REQUEST FOR INFORMATION

Addenda #1

Date: 02-15-12
Response To: Project Bidders
From: Steve Wilson, City of Redmond
Subject: SW Deschutes and 12th Improvement Project WW 11-01

SHEET
C1
OF 1 SHEETS

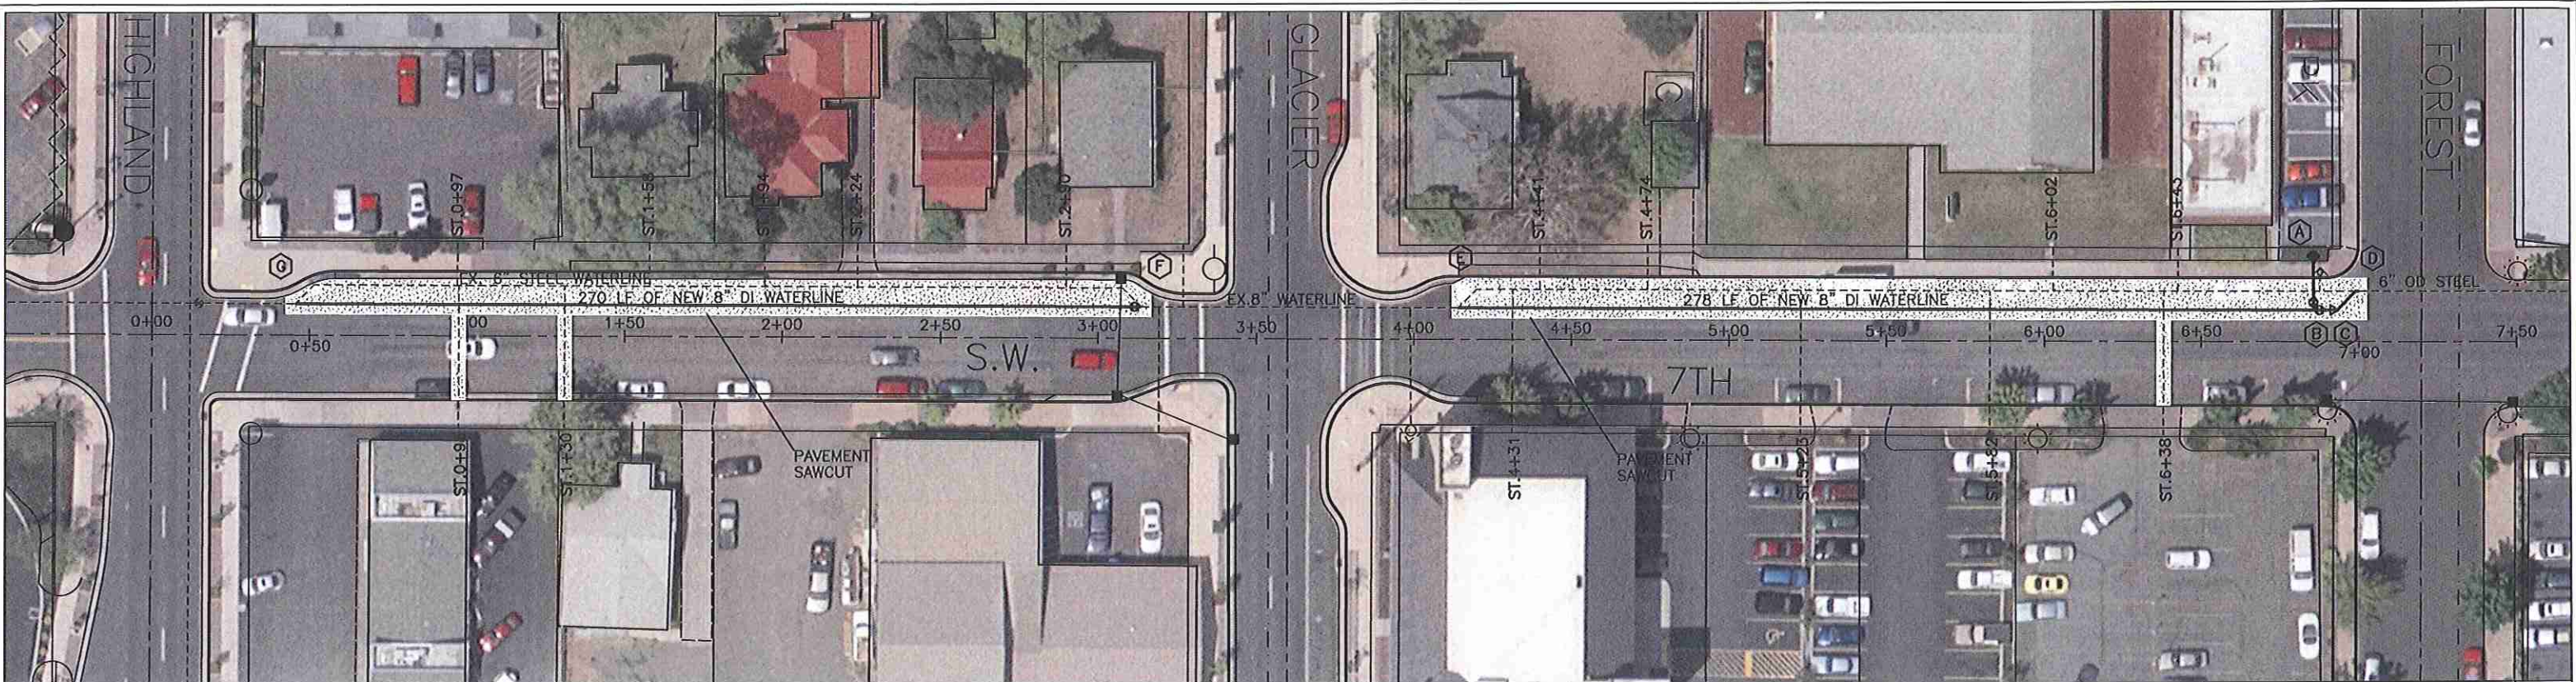
- h. The concrete islands located between the ADA ramps at the curb returns are to brick pattern stamped.
- i. The scale on sheet C1, 7th Street is incorrect. The pipe lengths called out on plan are correct. An 11 x 17 copy is included with the addenda plotted at 1"=50' for reference.

- o. Waterline tie-in at Black Butte and 12th is connecting to an 8" DI stub, not a 12" DI as mislabeled on plans.
- p. On sheet C1, SW 7th Street, notes state, "pull service". It is the intent of the City to not have additional trench cuts, so the service is to be disconnected from the old main and pulled from the meter side out from under the street. If the service does not pull, the City will decide at that time whether we want the road trench cut and patched or the service abandoned in place.
